Access Compliance Report

Public Rights-of-Way

(Pedestrian Signals)

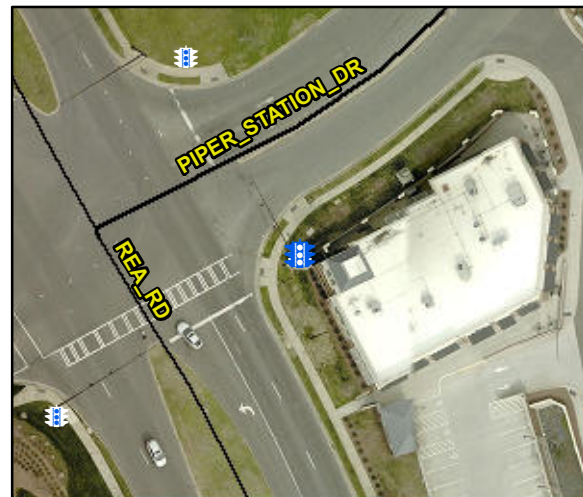
Intersection ID: N/A	Main Street:	Cross Street: N/A	Location: N/A
ADA ID: CA9C427C9CB4	Signal Type: One Push Button-Non APS	Overall Compliance: No	Severity Score: BTN 1: N/A BTN 2: N/A No BTN: N/A
Codes/Mitigation Info/Possible Solution		Field Measurements/Component Compliance

PROW/ADA: TMUTCD 4e.08, R404.3, R404.2, R404.7.1, R404.7.2

Possible Solutions: Replace Signal Push Button With APS Button on New Post. Remove & Relocate Sign.
